**REPORT
TO
BOTANY BAY CITY COUNCIL
IN RESPONSE TO
THE
LATEST
DESIGN REVIEW PANEL REPORT
DATED
FEBRUARY 2010**

This Report has been co-ordinated by James Nangle of Planning Strategies Pty Ltd

MARCH 2010

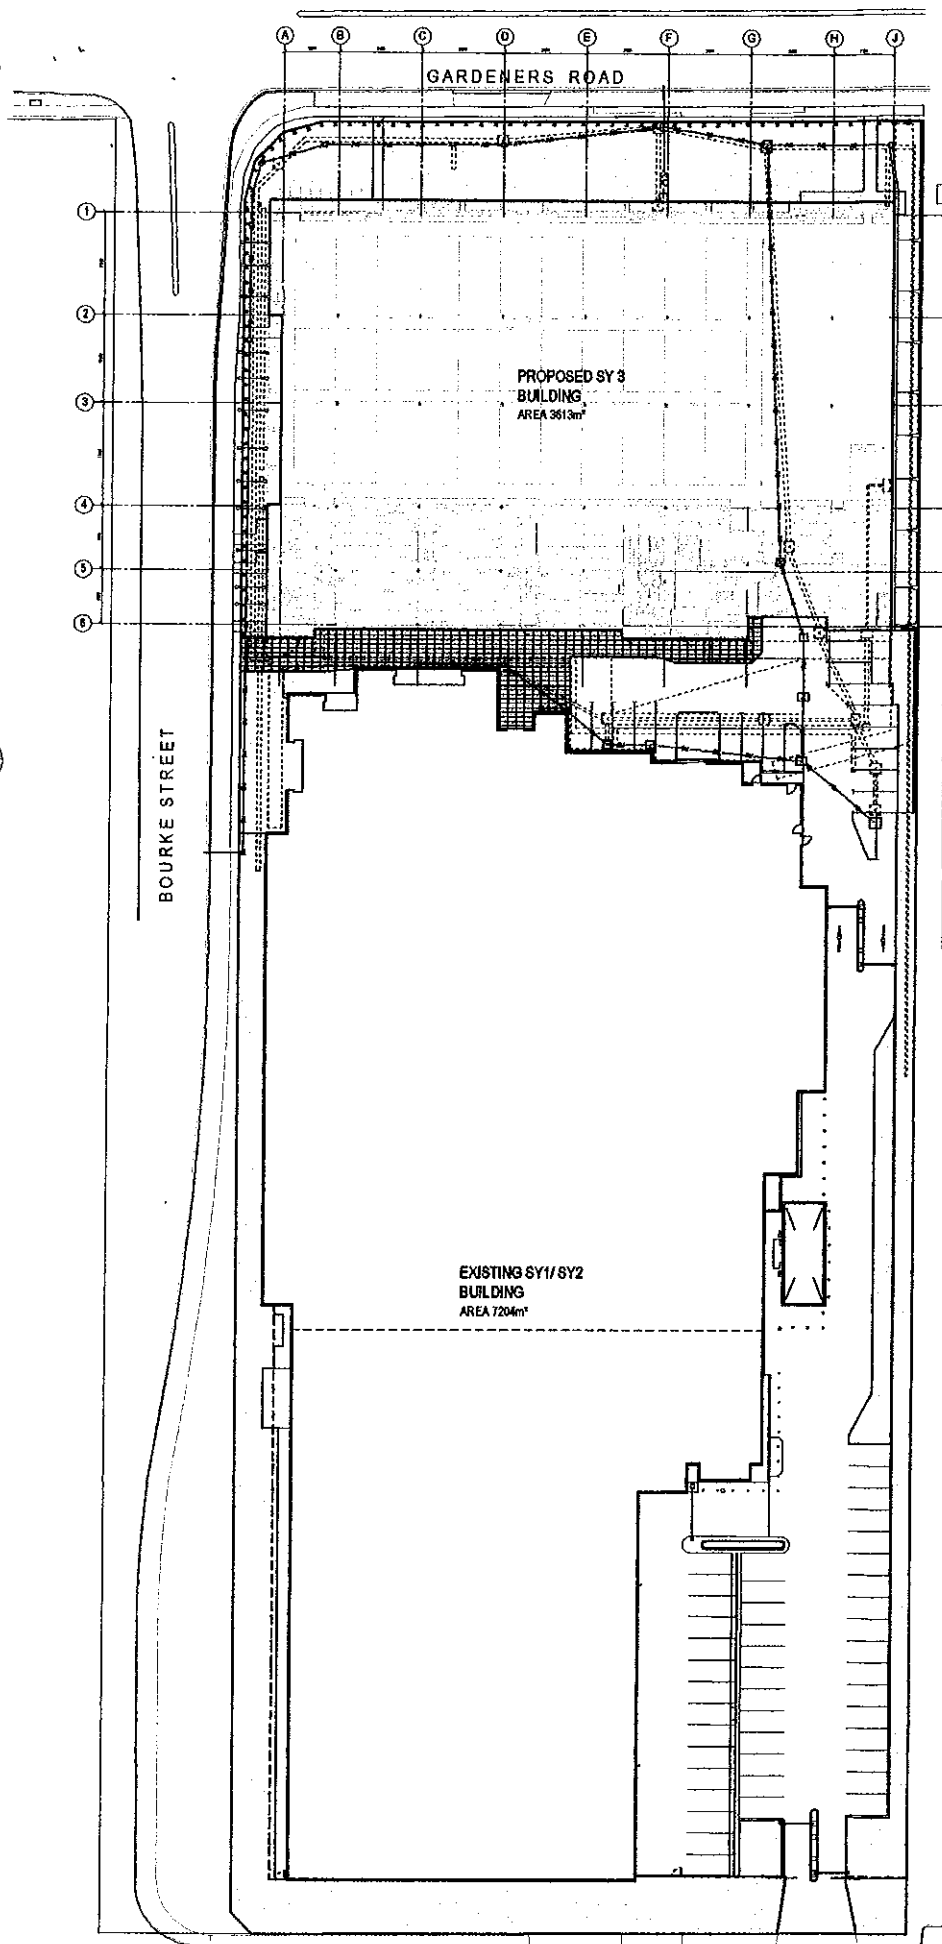
- 1 metre wide planting strip and 3 metre masonry wall on the boundary is worthwhile
- Further landscape including trees between the new building and existing building to the south, an area considered to be bleak
- Strong recommendation that native planting extend around the corner to the maximum extent, both on private and Council land – architectural emphasis proposed at the corner would still read very strongly

A 3.0 metre wide planting strip can be achieved along the eastern boundary (see attached plan)

The area between the proposed building SY3 and existing SY1 is required for an emergency access corridor however this area can still be used as common open space and therefore there is 18.4% of the site as open space; it is also noted that in terms of the DCP, 90.6% of the common open space is deep soil planting considerably more than the 25% required (see attached plans)
